CHARACTER AMERICAN ENTERPRISE
Los Angeles Examiner
OFFICE OF THE PUBLISHER
BROADWAY AT ELEVENTH ST., LOS ANGELES

Feb. 7, 1936.

Dear Miss Morgan :

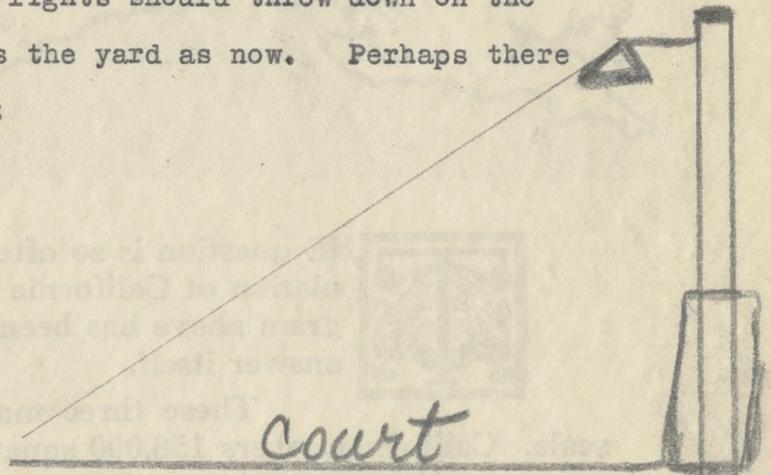
The lights should throw down on the nearest court-- not across the yard as now. Perhaps there should be an elbow, thus :

I think we can get along with the outer posts and with strong lights. The elbow could hold two lights or even three.
